Carter® Ground Fueling**PRODUCT NEWS BULLETIN**

PN348081006

**Product Improvement
Link Pivot Pin**

Applicable to all Carter brand Model 64348 Commercial and Models 64049 & 64349 Military Nozzles

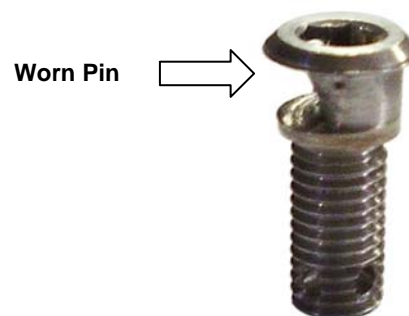
A key part of the 64348/64049/64349 family of nozzles has been redesigned to lengthen its life. The 220886 Pin (Item 31 Figure 2 of SM64348, SM64049, & SM64349) is part of the opening/closing mechanism. The material from which this part is made has been changed and hardened to reduce wear. The earlier design Pin was made of a 300 series corrosion resistance steel that can not be hardened. The new Pin will be made of A286 Corrosion Resistant Steel per AMS 5731 or AMS 5737 and hardened to C30 Rockwell.

The existing Pin has not changed since the 64348/64349 family of nozzles went into production back in 1992, but there have been several cases of excessively worn Pins discovered recently. Although this pin is subject to normal wear from continual use, wear is accelerated on the pin by even slight "over" adjustment of the position of the poppet to stop/prevent poppet leakage. This adjustment is currently outlined in paragraph 8.1.4 of all three service manuals as follows:

This Pin is manufactured from a commercially available aerospace standard screw made of 300 series corrosion resistant steel, and recent Pins may have been made from a lower grade than those made previously. Owners of Model 64348, 64049 or 64349 Nozzles less than a year old may obtain a no charge replacement by providing their local Carter distributor with the serial number of their nozzle(s) in question. The following serial numbers qualify:

"Bearing diameter of item 31 Pin (.300 inches (7.62 mm) diameter min.)"

Additionally, if a nozzle requires repeated Poppet adjustments to prevent Poppet leakage, further inspection of this Pin should be completed to ensure that the problem is not being caused by a worn Pin.
